Subject: Submittal Supporting Accelerated ABWR Review Schedule - **Revised LCO**  
3.7.5

Enclosed is a SSAR markup of the revised LCO 3.7.5, Main Turbine Bypass System.

3.7.6<sup>5</sup> Main Turbine Bypass System

## ABWR Main Turbine Bypass Valve Failure Rate

Figure 1. Turbine Bypass Valve Hydraulic Fluid Control Loop

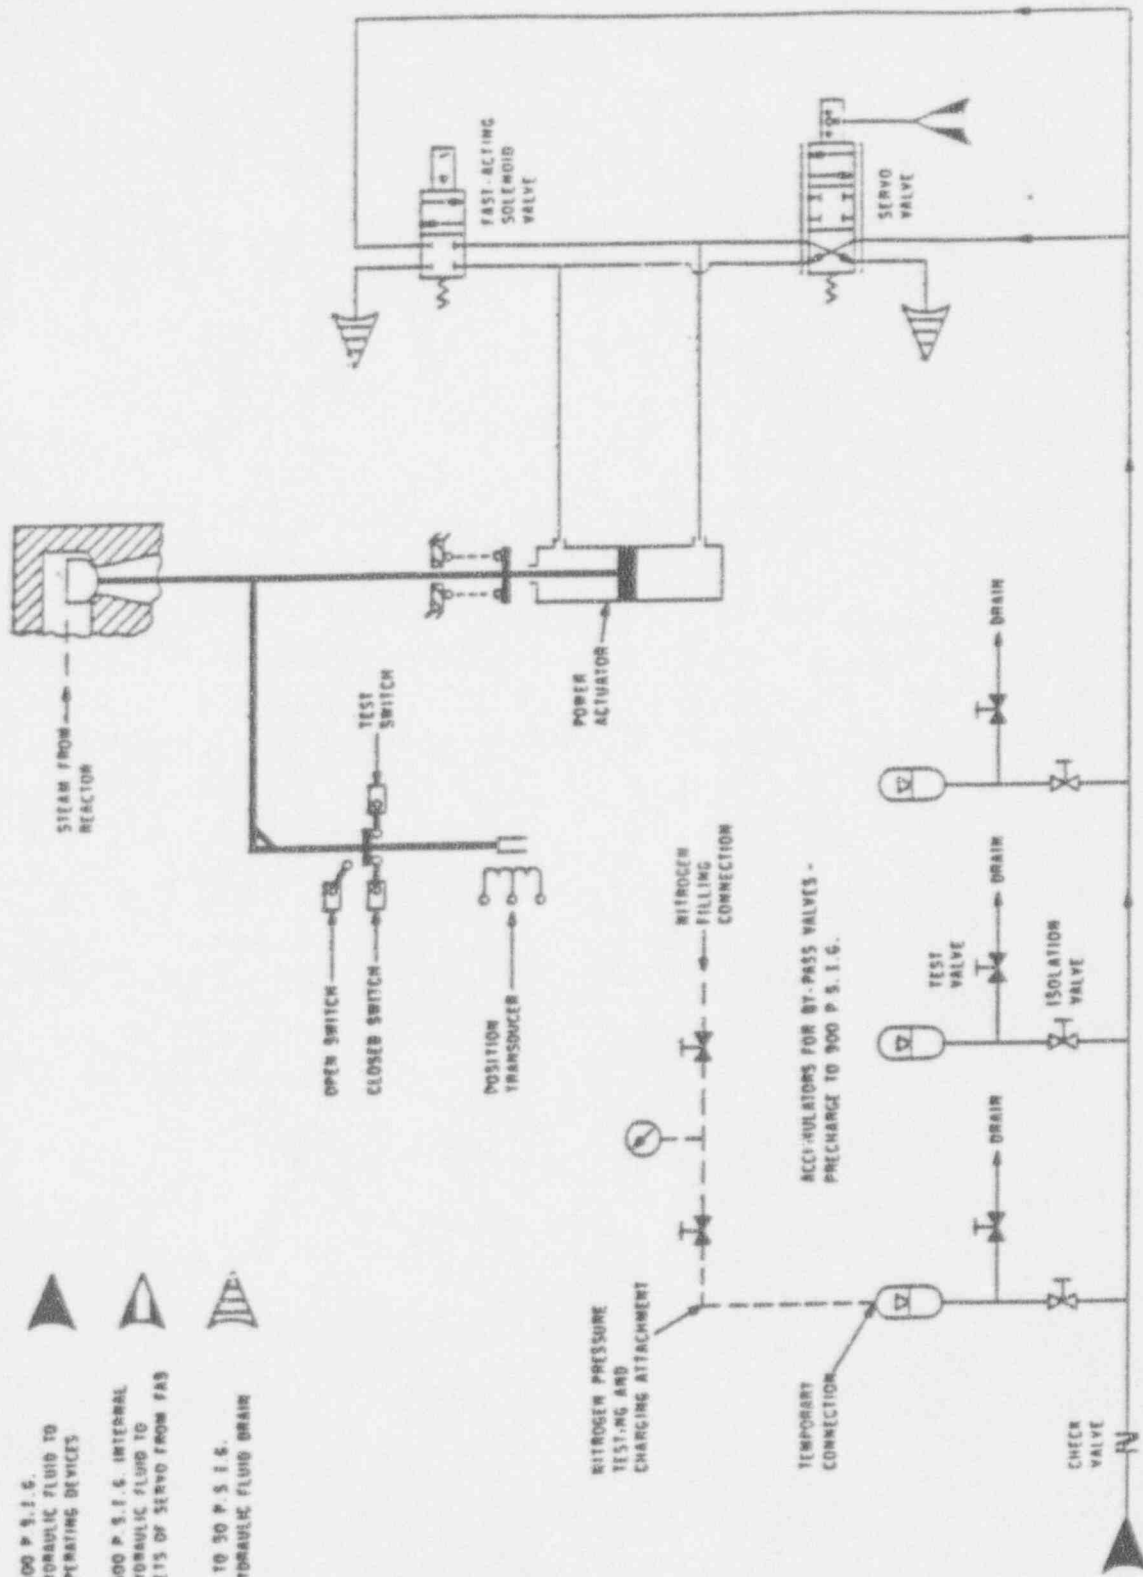
If a turbine trip occurs at high power, even fast action of the bypass valves will not avoid reactor scram. However, the proper BPV function will limit the pressure rise in the reactor. The hydraulic fluid loop showing the fast acting solenoid valve (FASV) and its connection to the BPV is shown in Figure 1. The FASV is the key to fast opening of BPVs.

Consideration was given to the probability that accumulator failure would preclude rapid BPV action when needed. The accumulators are precharged with nitrogen to 900 psig with the hydraulic system pump off. When the pump operates, system pressure climbs to 1600 psig. This pressure is maintained by the operating pump, and a standby pump will automatically start if system pressure drops to a preset value, indicating failure of the operating pump. If the accumulator leaks nitrogen, without being detected, and subsequently the operating pump fails and the standby pump fails to start, or starts and fails to run, the plant would be vulnerable to the FWC maximum demand event, with its assumed 0.05/year probability.

FIGURE 2. TURBINE BYPASS VALVE FAST ACTING SOLENOID VALVE CONTROL CIRCUIT

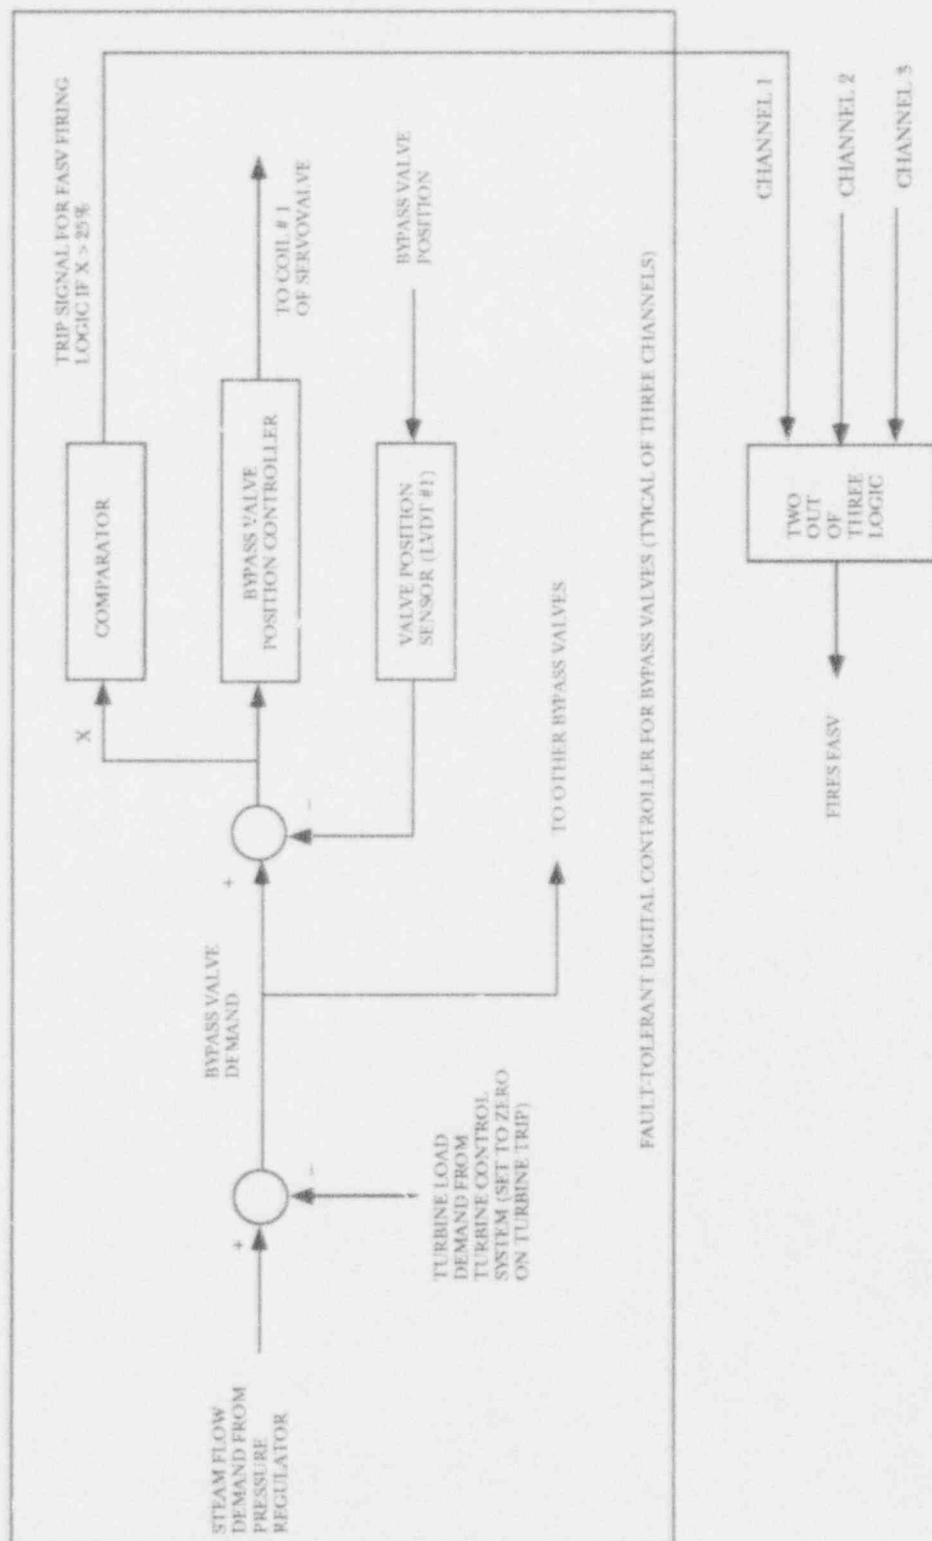
The circuit to cause fast opening of the BPV is attached as Figure 2. The fault tolerant, solid state digital controller components are checked frequently by the self-check circuits. They are also combined in 2-out-of-3 logic so there will be a very low probability of failures of the controller that lead to inadvertent opening of the fast acting solenoid valves (FASVs). Because of the high reliability of this circuit, the main contributor to failure of the FASV to perform its desired function will be the FASV itself.

The referenced IEEE Standard gives failure rates for much nuclear plant equipment, including solenoid valves. The "all modes" failure rate for solenoid valves is  $1.32\text{E-}6/\text{h}$ , but this is primarily for "catastrophic" (spurious open or spurious close) failures,  $0.95\text{E-}6/\text{h}$ . The failure rate for "degraded" performance is  $0.37\text{E-}6/\text{h}$ . A demand failure rate of  $1.08\text{E-}6/\text{d}$  is also given in IEEE 500-1984.

The demand failure rate for solenoid valves is very low, and demand failure rates are generally not time dependent. Therefore, it will be assumed to be independent of test frequency. It is pessimistic to assume that the time dependent failure rate is dominant, in which case the failure rate will be proportional to the test interval. For such a pessimistic approach, the average failure probability during a time interval T is given as
